# UNITED STATES PATENT AND TRADEMARK OFFICE

APPLICATION NO.	FILING DATE	FIRST NAMED INVENTOR	ATTORNEY DOCKET NO.	CONFIRMATION NO.
10/698,269	10/31/2003	William Gerald Wyatt	004578.1384	1666
45507	7590	06/06/2006	EXAMINER	
BAKER BOTTS LLP 2001 ROSS AVENUE 6TH FLOOR DALLAS, TX 75201			FORD, JOHN K	
			ART UNIT	PAPER NUMBER
			3753

**Office Action Summary**

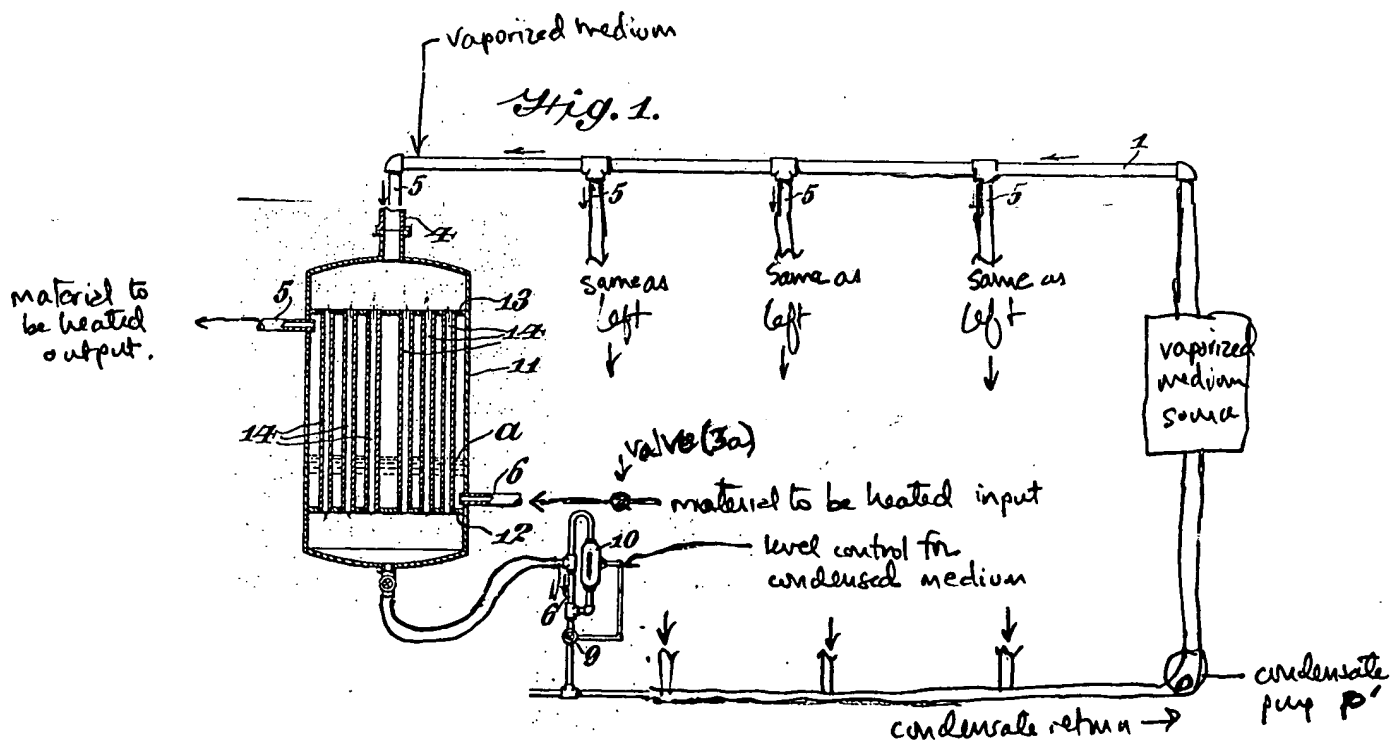
Claims 1-8 are rejected under 35 U.S.C. 112, second paragraph, as being indefinite for failing to particularly point out and distinctly claim the subject matter which applicant regards as the invention.

It is not understood, particularly in regards to claims 2 and 3, which disclosed "further conduit" is being claimed in claims 2 and 3. Are these conduits 93 and 94 or are they a claim to a further module as shown in Figure 2 at 21 and 22? The nature of the "predetermined direction" (claim 1) and the "approximately perpendicular to said predetermined direction" (claim 2) and "further direction" (claim 4) is particular unclear because no particular "direction" relative to some identifiable heat exchange structure is specified. Without some reference direction these directions could be in any arbitrary direction. Please specify these directions relative to the rest of the claimed structure.
